**AGENDA
FOR THE CITY OF OLIVETTE
PLANNING AND COMMUNITY DESIGN COMMISSION
MEETING OF APRIL 7, 2016
AT 7:00 PM
IN THE OLIVETTE CITY COUNCIL CHAMBERS
AT CITY HALL GOVERNMENT CENTER
LOCATED AT 9473 OLIVE BOULEVARD**

1. Roll Call
2. Review Of Commission Procedures
3. Consent Business
 - A. 43 Enfield Road
Site Plan and Community Design Review for:
2-level addition in front of home and
1-level addition in rear of home.
Petitioner: Mike Dinzebach, M. Dinzebach Construction, LLC
Owner: Rebecca and Joseph Schulz

RE: 43 ENFIELD DRIVE
PRELIMINARY STAFF REVIEW OF PETITION FOR COMMUNITY DESIGN & SITE PLAN
REVIEW

Installation Example:

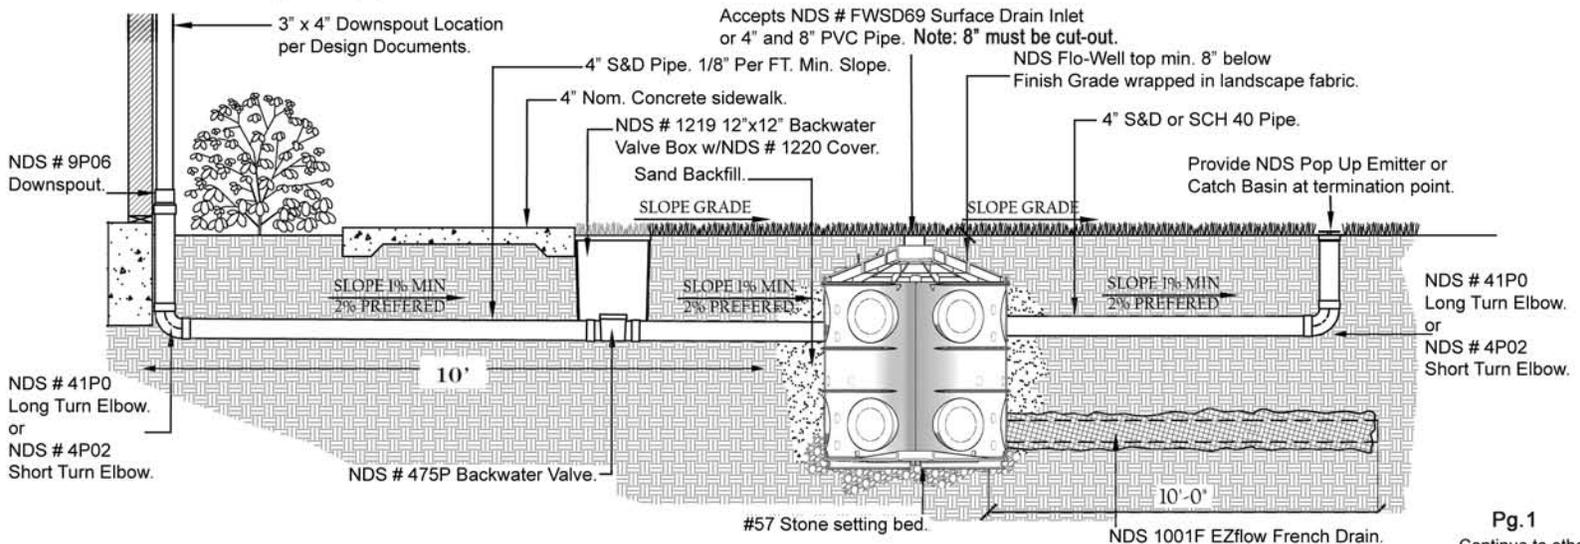
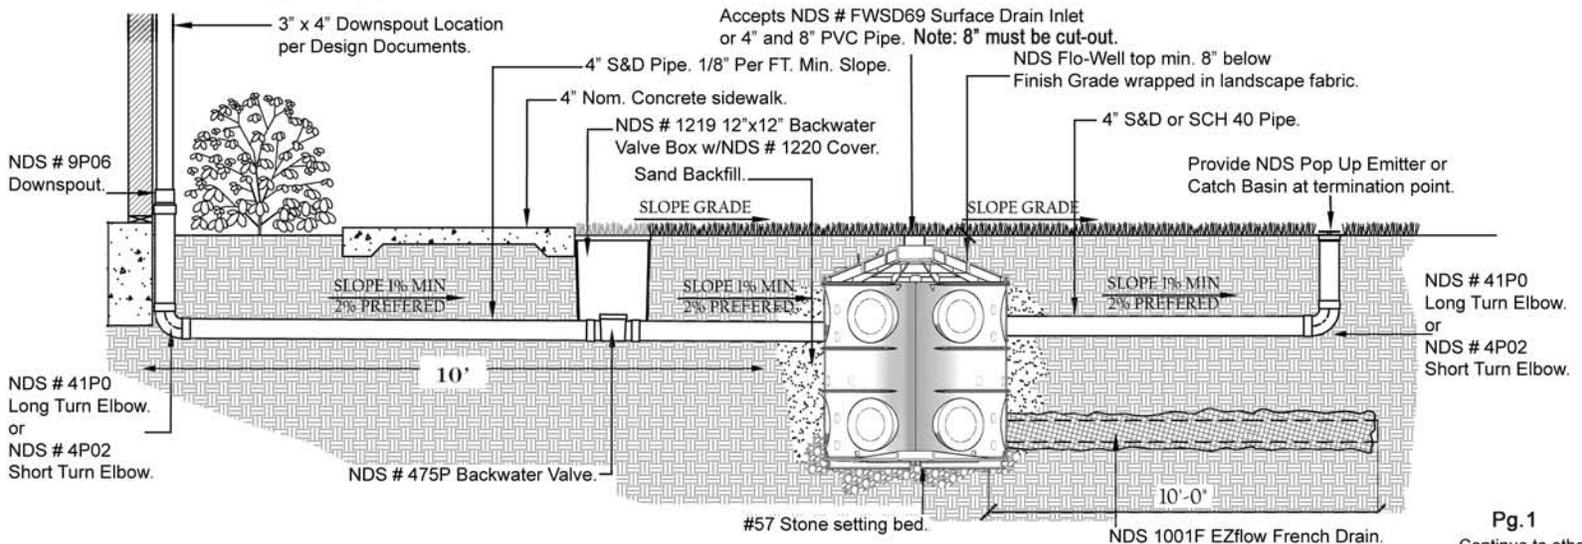
The size and amount of runoff being captured in the proposed Flo-Well Dry-Well Systems has not been identified. Provide the differential run-off calculations of each drainage area based on a 15-year 20-minute storm event. The amount of runoff captured by the Flo-Well Dry-Well System must be sized to fit the demand.

SITE PLAN

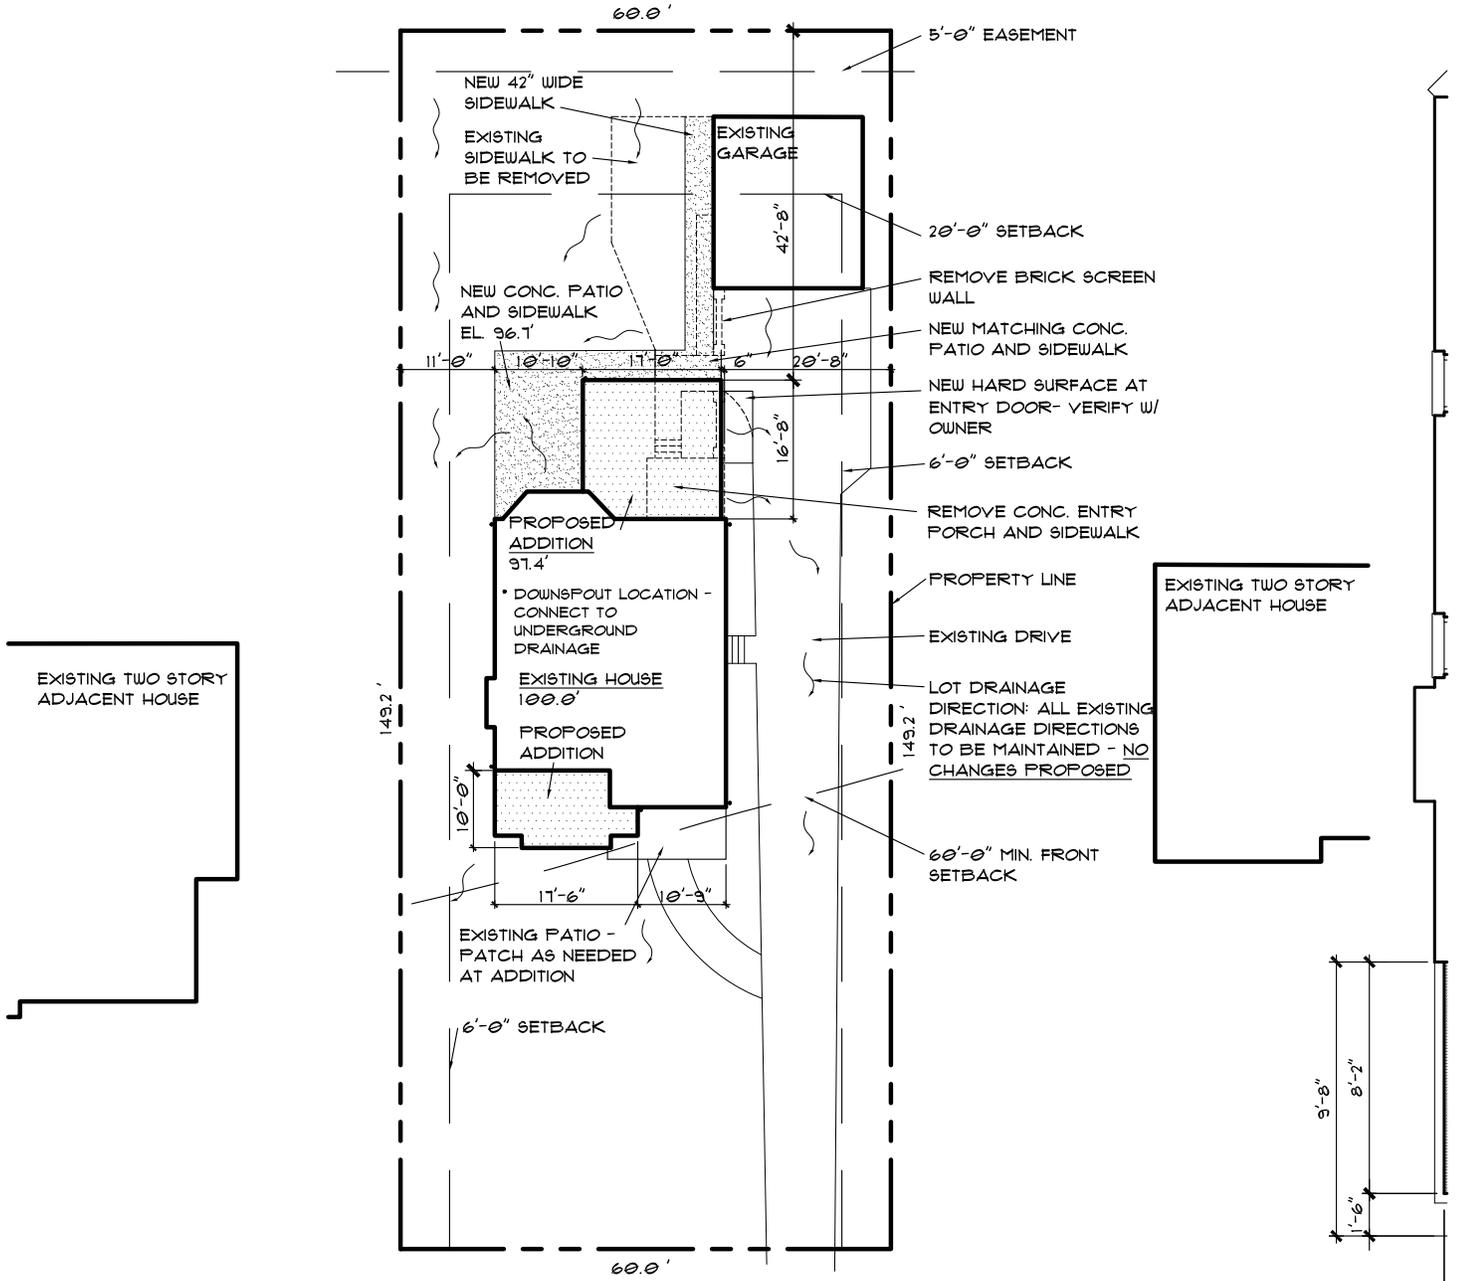
From the onsite meeting on Monday, March 21, 2016, it was noted various segments of the walkway near the garage is to be removed. A revised site plan must show the area and provide the area square footages within the Lot Data and Zoning Regulations Table. The site plan must indicate the following:

- Exhibit 1 - Lot Data and Zoning Regulations Table
- Site Plan to illustrate flatwork/patio area to remain.

1. Improvements which fall under Article XVI Accessory Structures and Uses (patio & sidewalk) exceed the maximum lot coverage for accessory structures.
2. Lot Data and Zoning Regulations are missing.
3. Stormwater management plans must be provided.

For the subject lot, 25% of the required rear yard is 450 sf. (rear yard setback of 30-ft by 60-ft width is 1,800, 25% is 450 sf.). There are existing accessory structures on the site that exceed 25% of the rear yard area, 418 sf. detached garage and 260 sf. existing rear side walk area. As the existing accessory structures total square footage exceeds 450 sf., additional accessory structures require Site Plan Review and Conceptual Stormwater Management Plan.

- The square footage of all areas must be provided in a Lot Data and Zoning Regulation Table as provided in Exhibit 1, and
- Site Plan illustrating the improvements with areas that do not exceed 10% of the lot area.

The plans note “downspout location – connect to underground drainage”. Additional information must be provided to note which downspouts to be connected to underground drainage, the capacity of the underground storage unit, capacity of pipe leading to the drainage system, and pop-up locations for the overflow or release points.

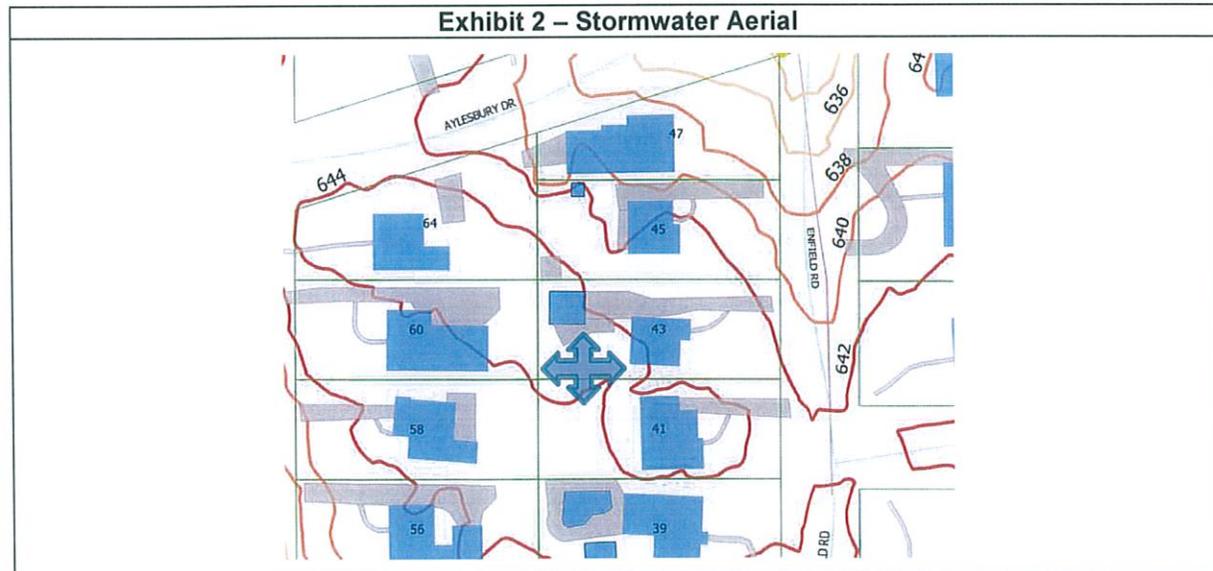
Exhibit 1 - Lot Data and Zoning Regulations Table	
<input type="checkbox"/> A table similar to the one below showing the calculated site coverage of each of the following existing improvements:	
building footprint	X,XXX sf.
driveway/turnaround/sidewalks	X,XXX sf.
Other hard surface areas (decks/pools/etc.)	X,XXX sf.
TOTAL EXISTING IMPERVIOUS AREAS	X,XXX xf.
<input type="checkbox"/> A table similar to the one below showing the calculated site coverage of each of the following proposed improvements:	
building footprint	X,XXX sf.
driveway/turnaround/sidewalks	X,XXX sf.
Other hard surface areas (decks/pools/etc.)	X,XXX sf.
TOTAL PROPOSED IMPERVIOUS AREAS	X,XXX xf.
